PROJECT NAME: CHARLOTTE	PLOT DATE: 15-MAR-2016
PROJECT NUMBER: F EGC 019-4(20)	DRAWN BY: B. KIPP
FILE NAME: d78d062_nul_bdr.dgn	CHECKED BY: C. LEACH
DESIGNED BY: B. KIPP	SHEET 79 OF 499

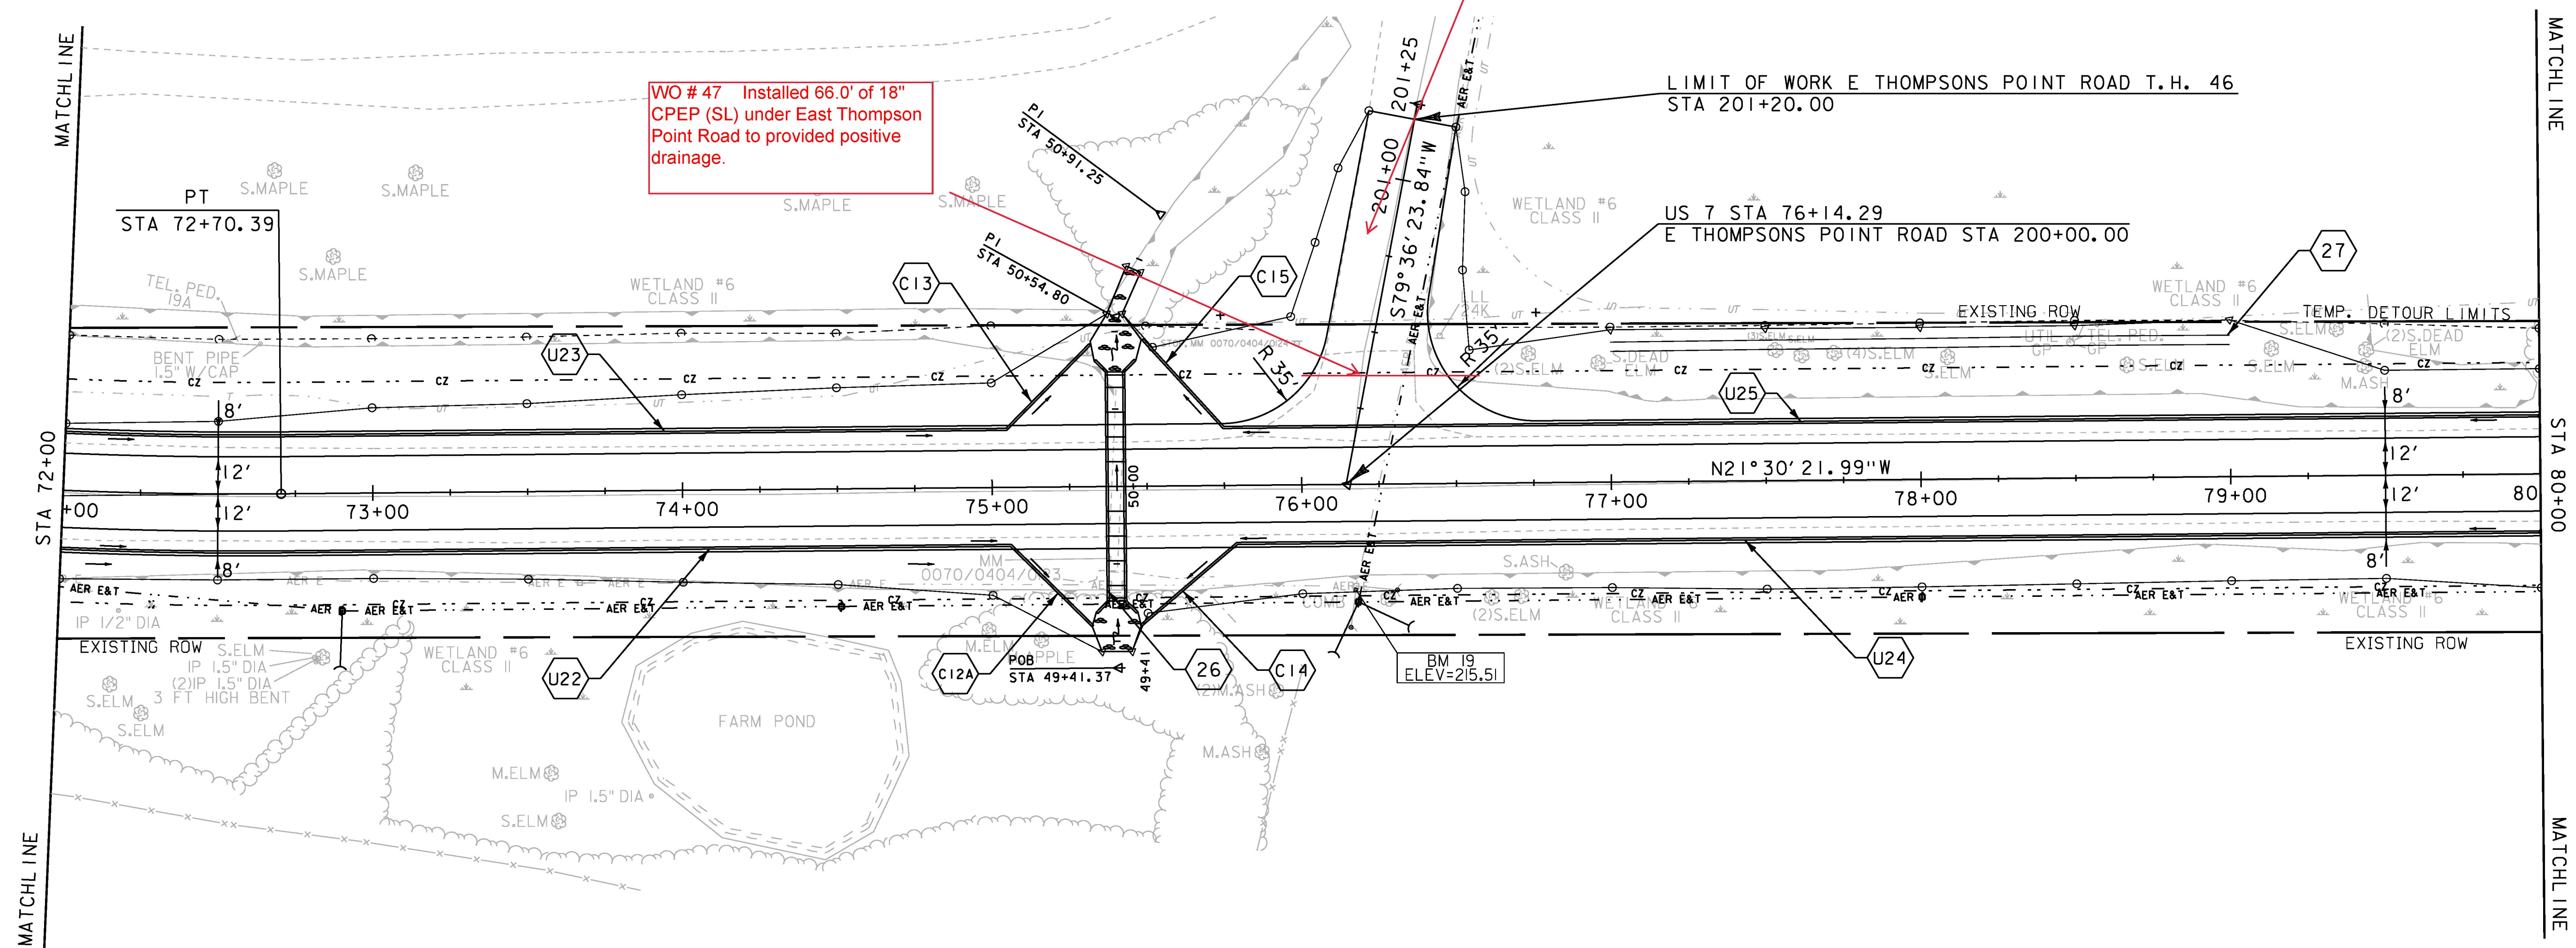
WO # 67 Pave 1 - 2-3/4" Lift of Type II S Pavement & 1 - 1-1/2" Lift of Type IV S Pavement @ East Thompson Point Road approach to Route 7.

WO # 47 Installed 66.0' of 18" CPEP (SL) under East Thompson Point Road to provided positive drainage.
